TECHNICAL BULLETIN INDEX
Sorted by Bulletin Number
04/03/86

BULLETIN NO: II:1

PRODUCT: 26-4001/2 Model II

Figure 1

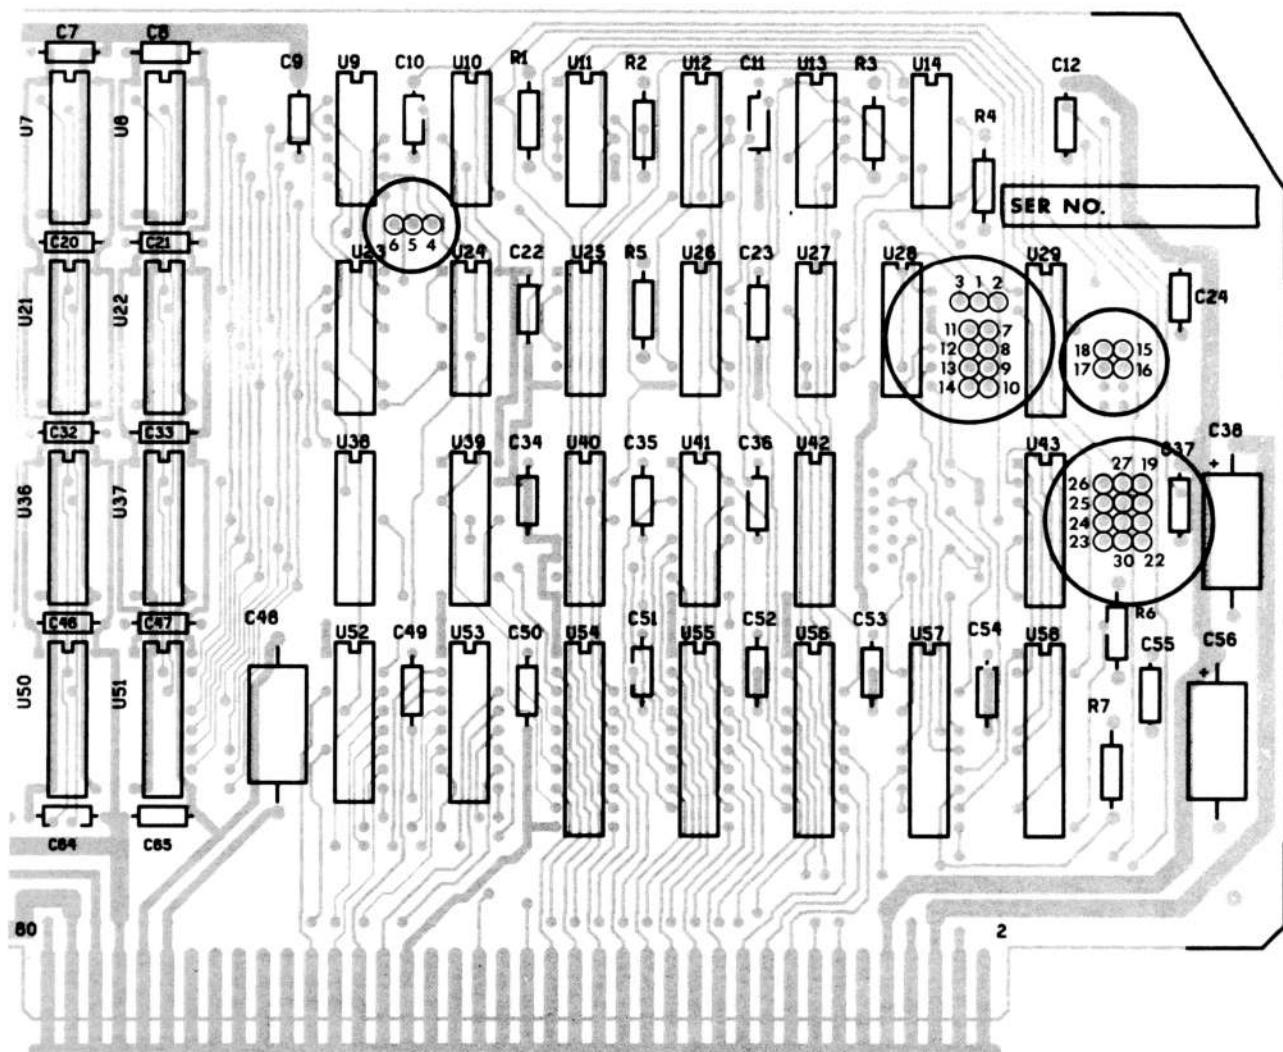
The following jumpers are required to be installed on all memory boards.

- 1-2 Pulls up an input to U27 that was floating
- 5-6 Pulls up an input to U9 that was floating

Figure 1

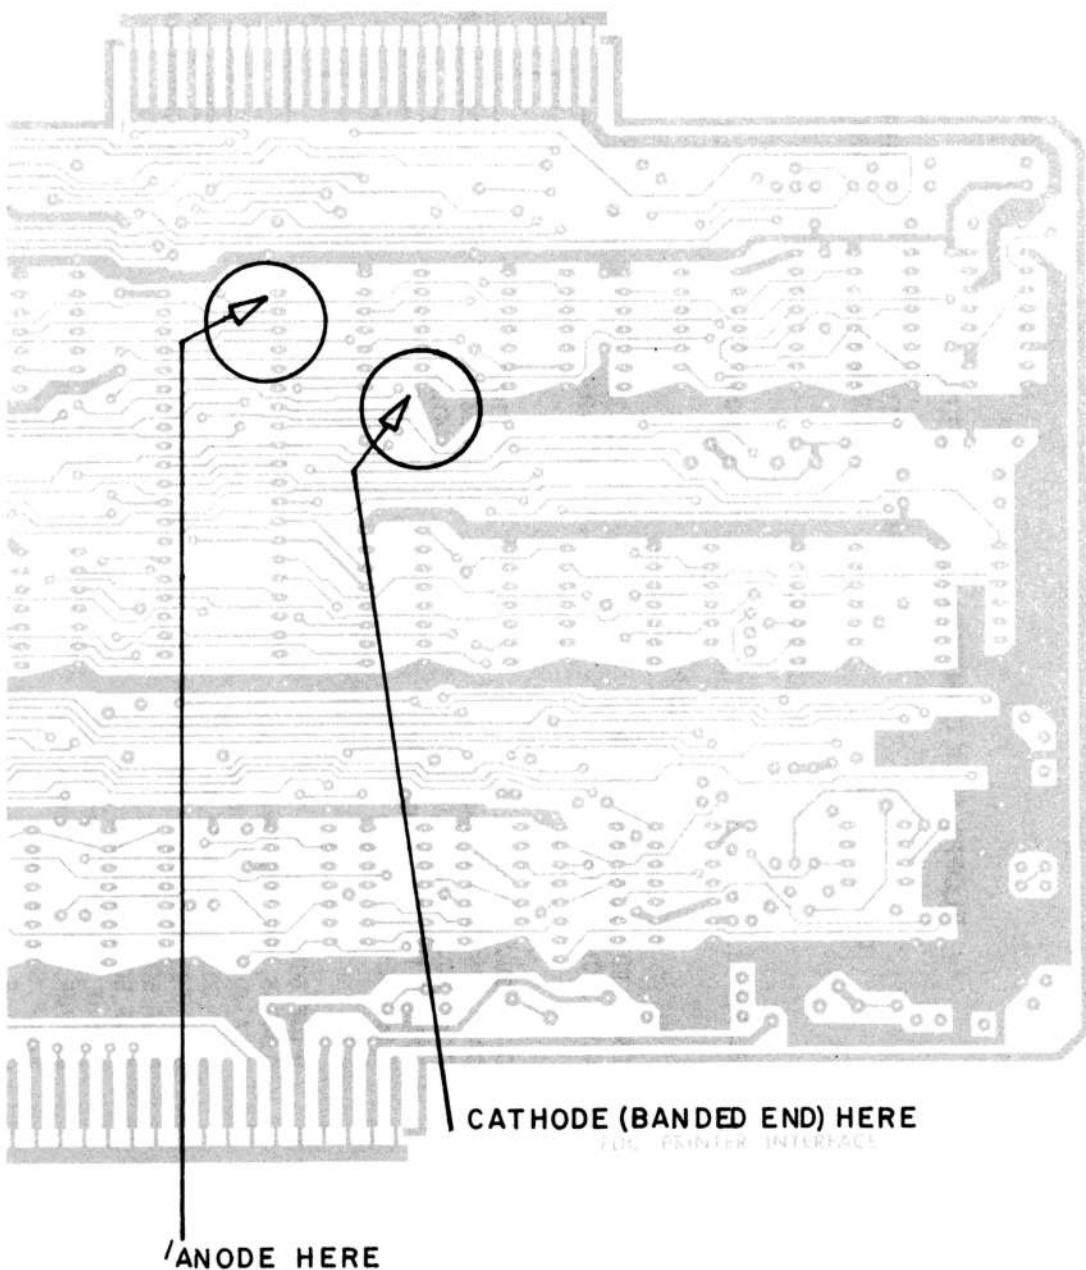
PURPOSE: To correct thermal failure of FDC IC (U6) causing Read/Write errors, and other intermittent disk I/O failures.

PROCEDURE: Check to see if this modification has been done, if not, install diode as per Figure 1. Be sure to use sleeving for insulation of leads to prevent shorts. This diode can be ordered from National Parts using part number ADX-1382 and catalog number 26-4001.

Figure 1

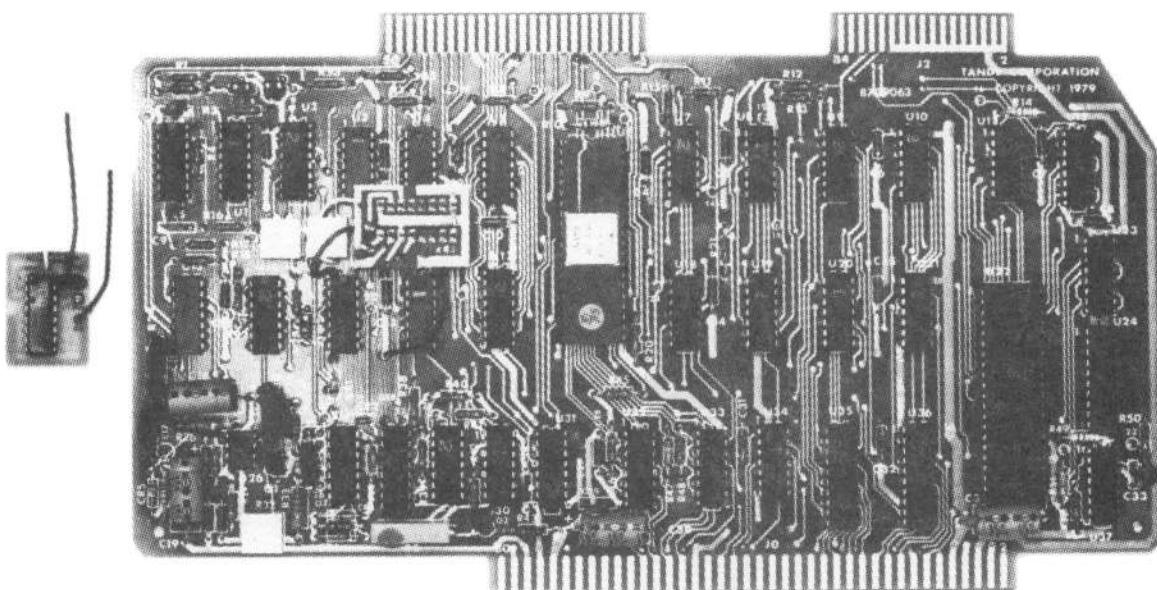
DISCUSSION: Early Design Rev A and B FDC boards require a modification to stretch the write pulse for proper operation with CDC LSI Logic Boards. This is accomplished by adding a satellite board (AXX-0506) to the existing circuitry. Rev C FDC boards have this modification incorporated on them so the modification is not required. To double check the Rev level of the board locate R49. On Rev B boards R49 is located next to the PIO chip (U22) and on Rev C boards R49 is located between U34 and U35.

Figure 1 is a Rev B FDC Board with the satellite board modification.

1. Cut trace on foil side of the board running from U3 Pin 1 to U16 Pin 3.
2. Dress red, black, and white wires coming from the satellite board to follow the routing shown in Figure 1.
3. Remove solder from the PCB pad that is to receive the stake pin. This is the pad connected to U16 pin 3.
4. Invert satellite module, insert stake pin, and solder the stake pin into place.
5. Reflow solder in unused PCB pads while inserting tinned satellite module leads as shown in Figure 1.
6. Align the FDC board as outlined in the FDCALG diagnostic alignment procedures. Alignment is **MANDATORY** after performing this modification.

Figure 1

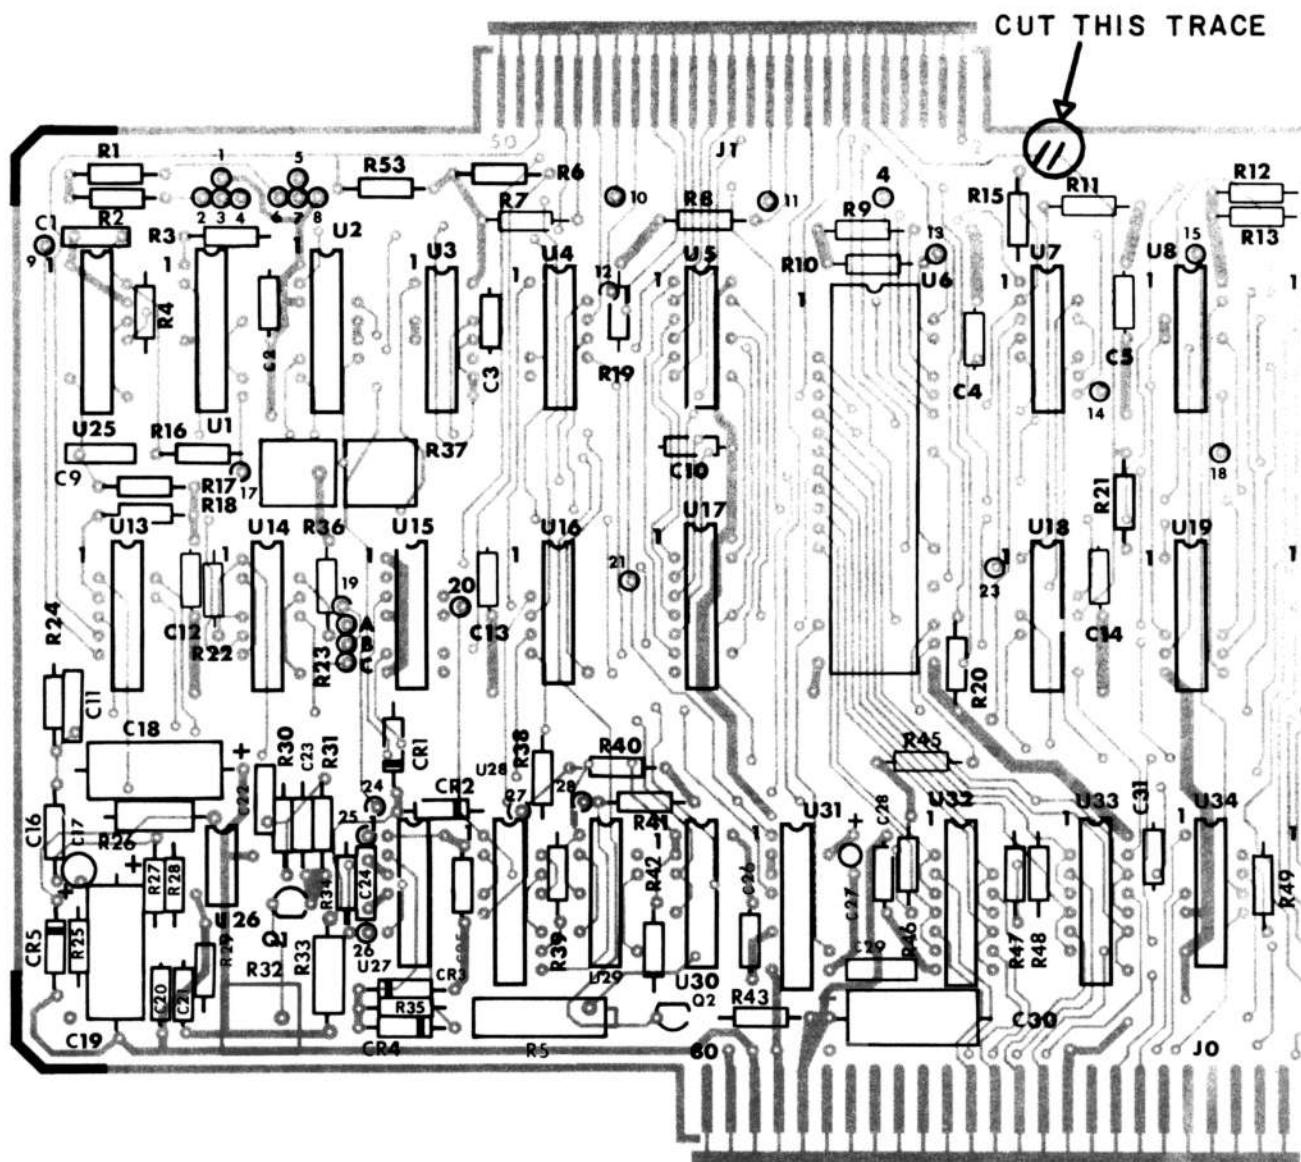
PURPOSE: To prevent Xenix from thinking there is a double sided disk in drive Ø when a terminator is used.

PROCEDURE: Locate and cut the trace connected to pin 1Ø of the disk drive connector on the FDC board (Refer to Figure 1).

Figure 1

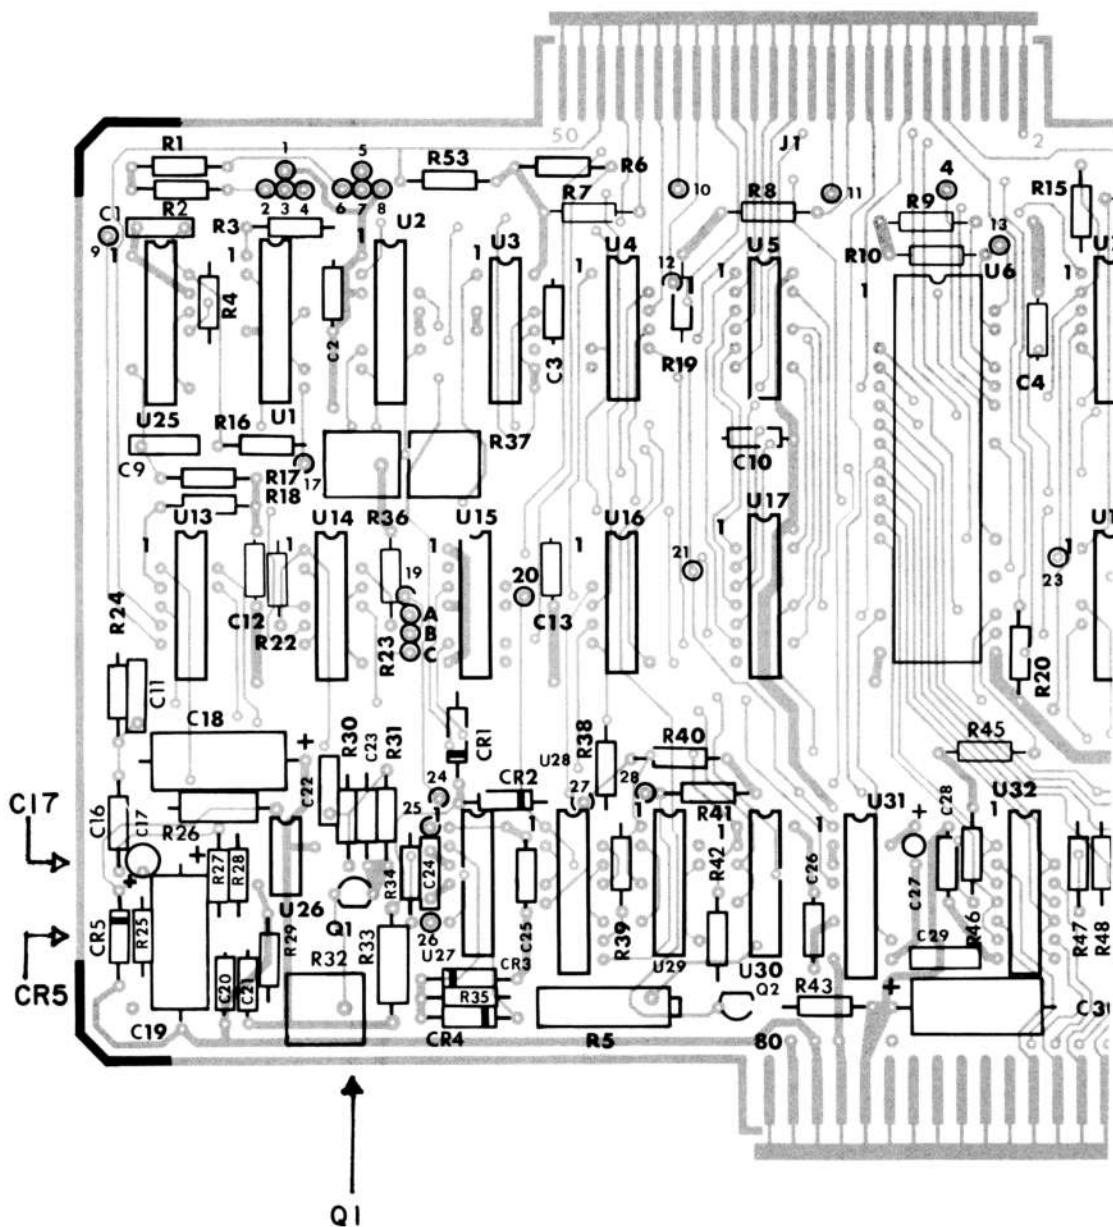
PURPOSE: To correct FDC Boards which have C17 installed backwards.

PROCEDURE: Check C17 on all units in for service to insure the positive(+) lead is going to ground. The most accurate method of checking this is by actually checking with an ohm meter continuity between the positive lead of C17 to ground. If capacitor is installed backwards replace with a new .47ufd tantalum capacitor(ACC-474MGTP). Do not just turn the old capacitor around as it has started degrading and life expectancy shortened.

FIG. 1

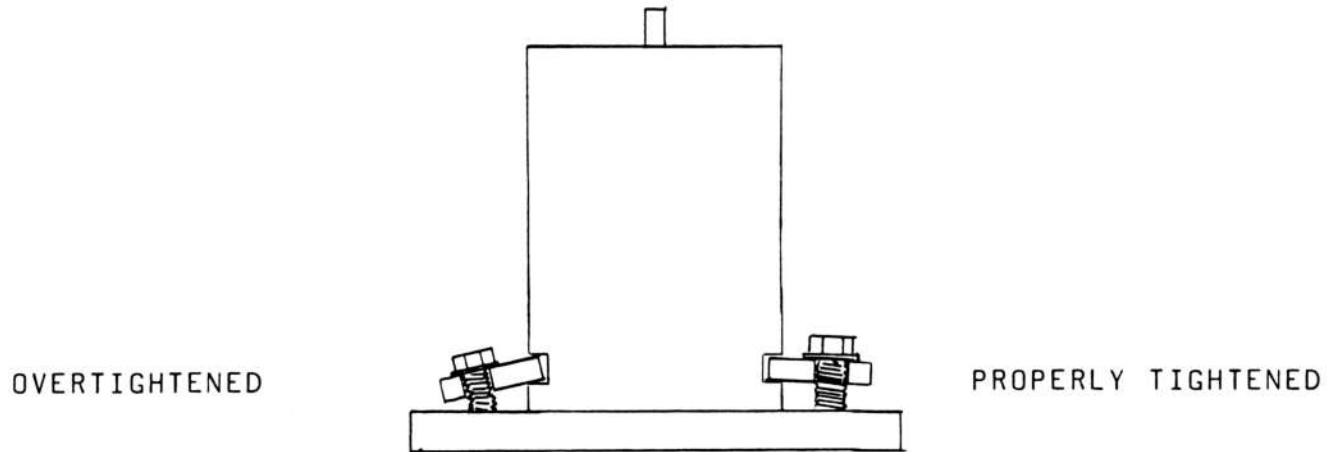
DISCUSSION: After aligning Head Radial DO NOT OVERTIGHTEN bracket screws when securing the stepper motor. Excessive tightening will cause bracket and screws to bend and eventually damage the screw holes in the stepper motor plate, making proper alignment almost impossible.

PROCEDURE: After Head Radial Alignment tighten bracket screws only enough to secure stepper motor. If the stepper motor cannot be secured without excessively bending the bracket (Refer to Figure 1), or if the screw holes in the plate are damaged, replace the drive chassis.

FIG. 1

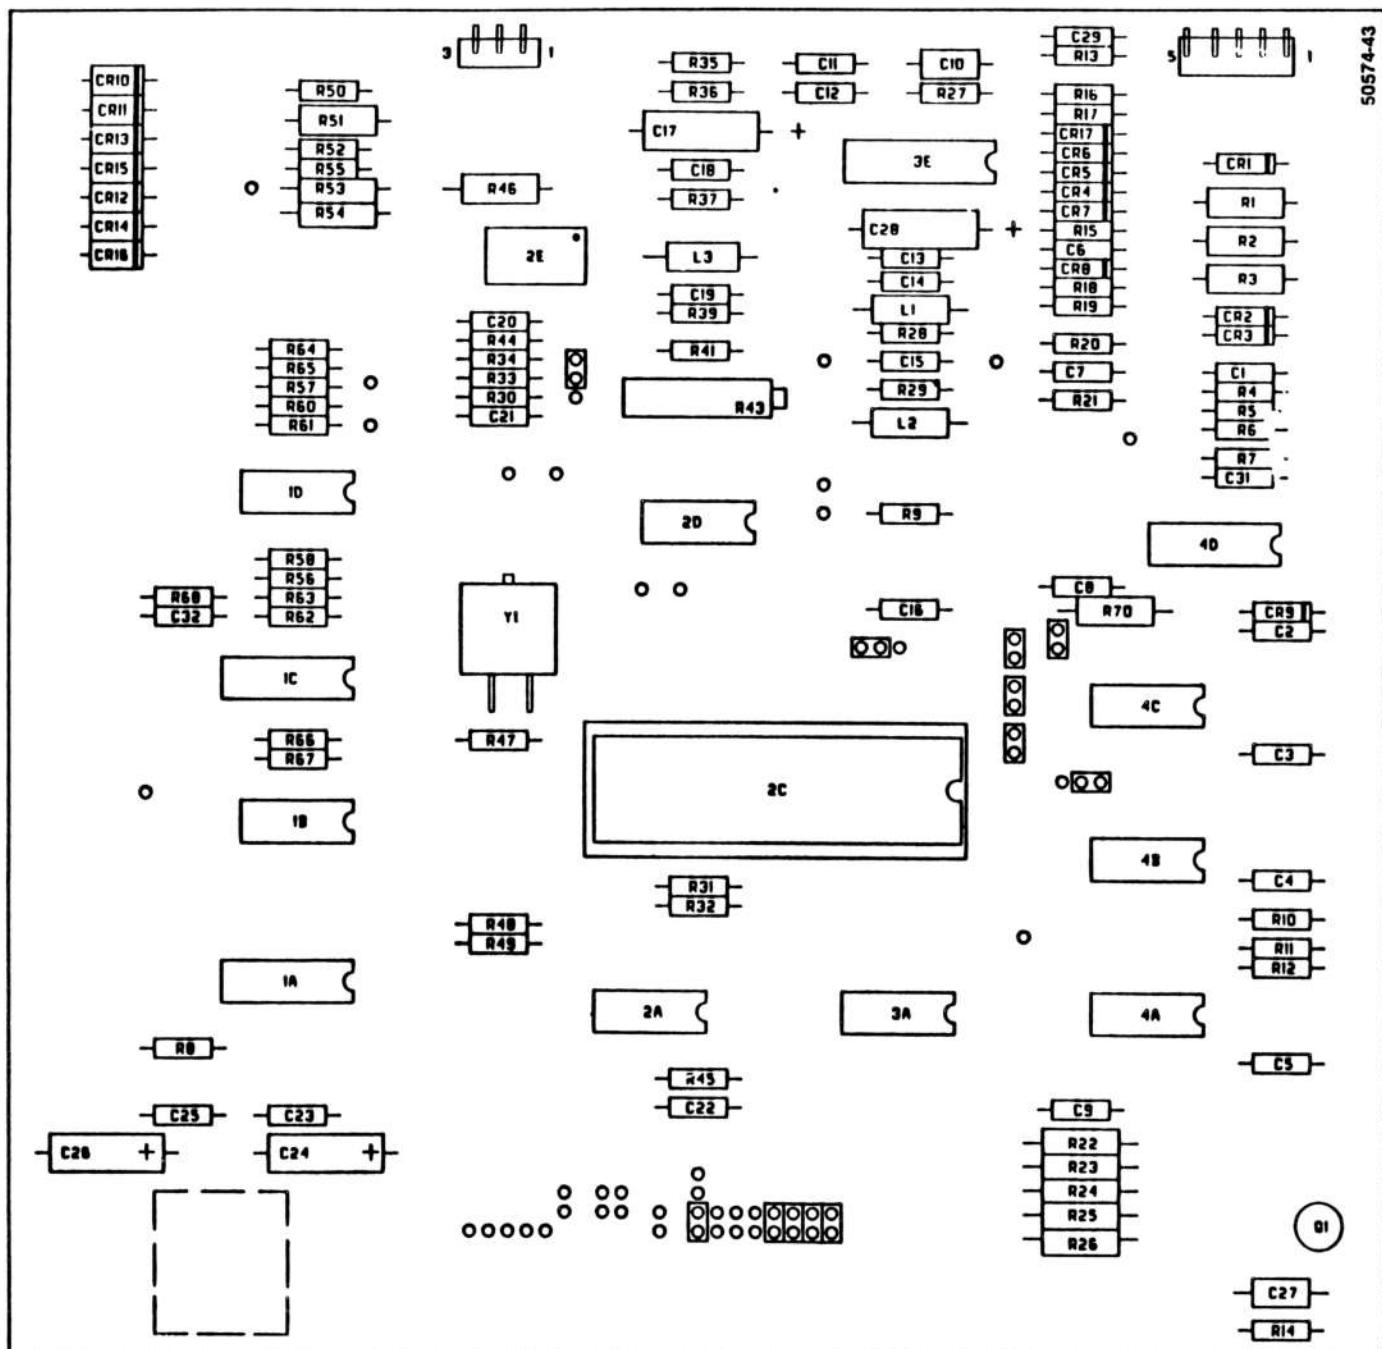
PROCEDURE: SOLUTION 1: Check board to insure .47 ufd capacitor is installed across C21 (Refer to Figure 1). This capacitor should be on all LSI boards, if not present, install capacitor with negative lead going to ground. Any value from .47ufd to .68ufd is acceptable. ACC-474MGTP is the National Parts Number for a .47ufd 35V capacitor. Later boards had the capacitor value at C21 changed.

Figure 1

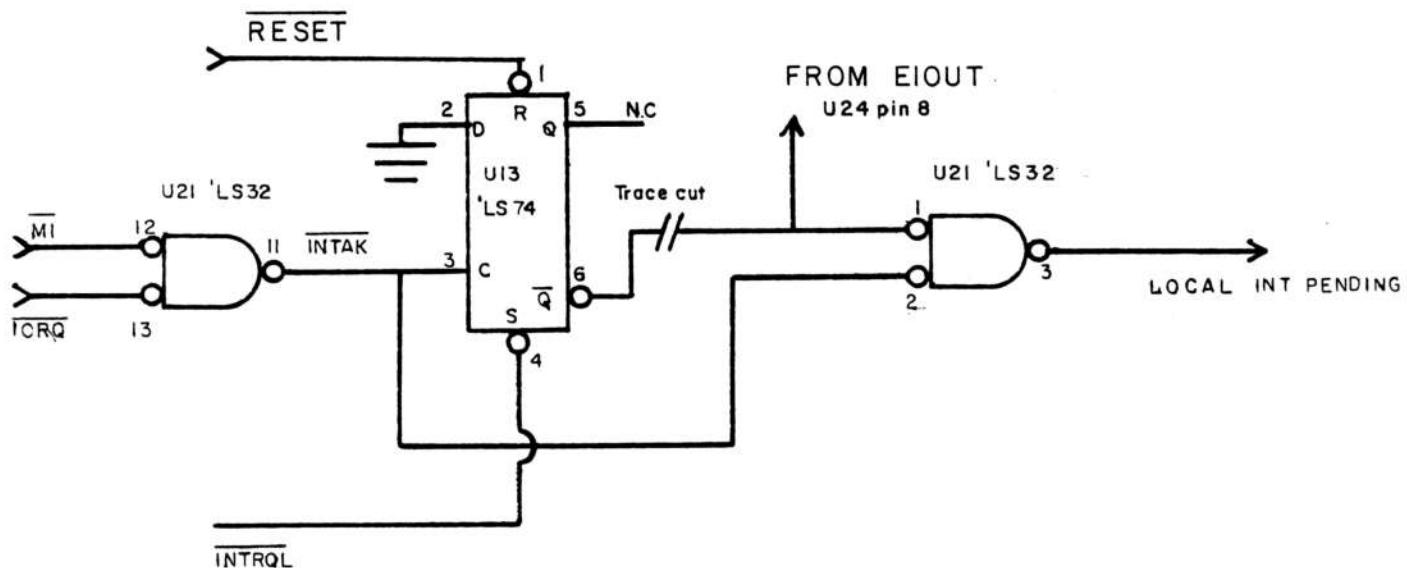
Refer to Figure 1 for schematic changes affected by this modification. The signal Local Interrupt Pending is now ANDed with EIOUT, and not with INTRQL. Previously, if the SIO programming was changed with interrupts disabled, a local interrupt could set flip-flop U13 without being serviced. Later, when an off board interrupt occurred, the bus steering logic would mistakenly interpret this as an on-board interrupt and would not turn the external data receive buffers. By ANDing the EIOUT signal with INTAK signal this problem is eliminated.
